Remarks

Applicant respectfully requests reconsideration and reexamination. The status of the claims is now as follows:

FIG. 3

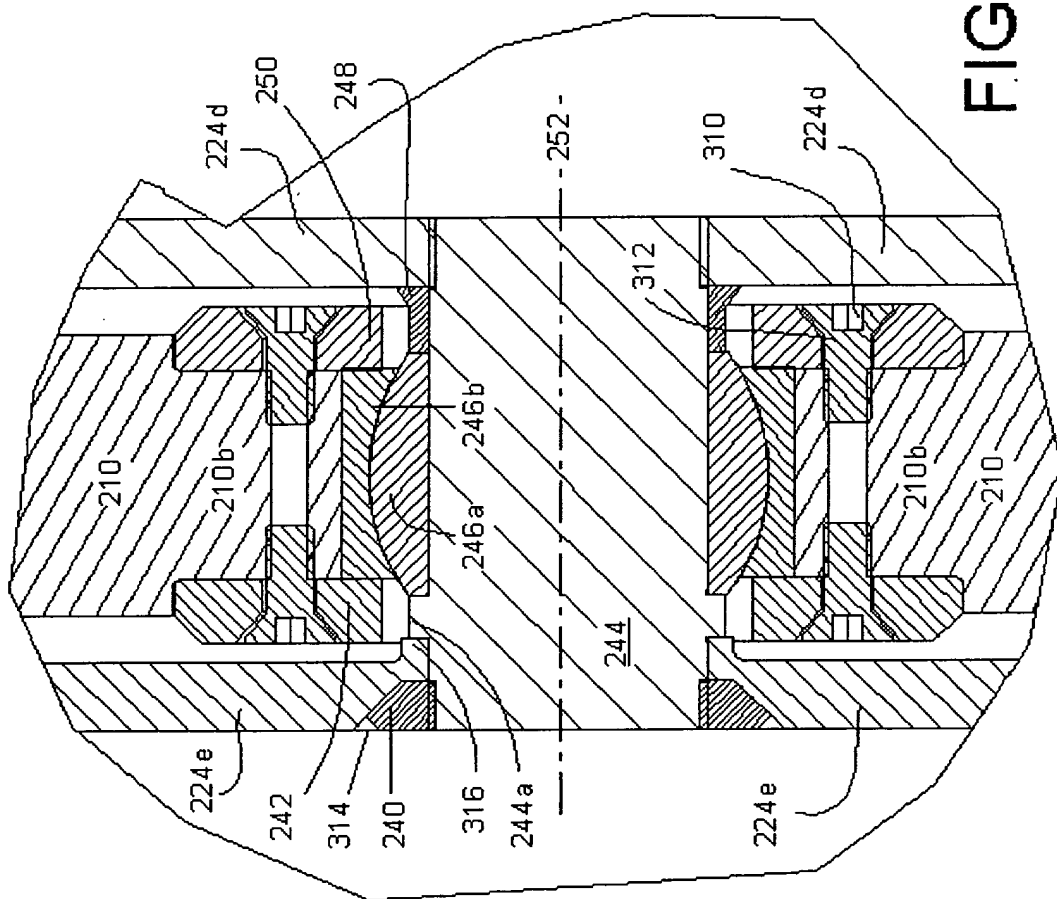
The Examiner has objected to the drawings because Fig. 3 shows only reference numerals, lead lines, and other seemingly random lines. This error was caused by an undetected software defect, wherein Applicants' CAD software failed to print an entire layer of the figure.

Applicants have supplied a complete Fig. 3, which now includes the previously missing layer. Although the content now shown in Fig. 3 was not initially provided, it is described in the specification as filed and can also be seen in the exploded view of Fig. 2. Therefore, no new matter has been added. A revised Fig. 3 is enclosed herewith, along with a separate letter to the Official Draftsperson.
